# RENESAS TECHNICAL UPDATE

Product Category	Transistor		Document No.	TN-LTR-A001A/E	Rev.	1.00
Title	Addition of Production Line for MPAK		Information Category	Change or addition of Production Line		
Applicable Product	RQK****DQA,RQJ****DQA Series 2SC5772,2SC5773,2SC5890, 2SD2655,2SB1691	Lot No.	Reference Document			
		all

## The comparison of frame supply method

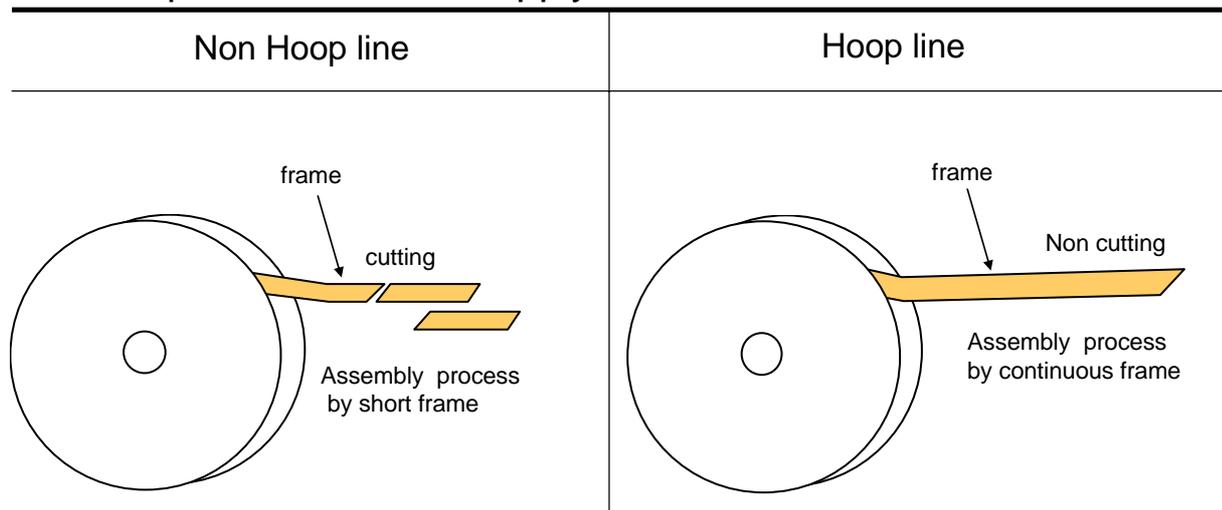
3.Contents It will use the hoop line together in the future though these are produced on the non hoop line now.

The table shows before and after change of assembly line

Assembly line	
before	after
Non Hoop line only	Non Hoop line or Hoop line

The comparison of externals photograph

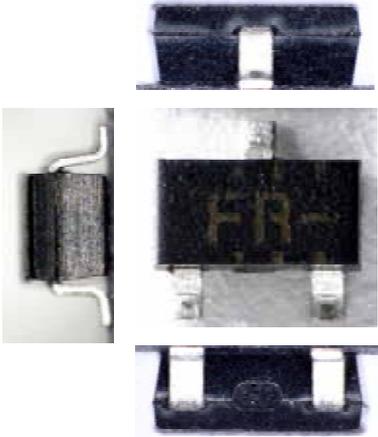
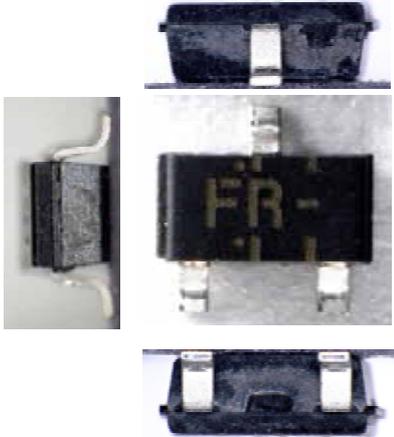
1.This is 2SC5772

Non Hoop line	Hoop line
 <p data-bbox="630 1077 746 1122">Magnification :X15</p>	 <p data-bbox="1241 1077 1358 1122">Magnification :X15</p>
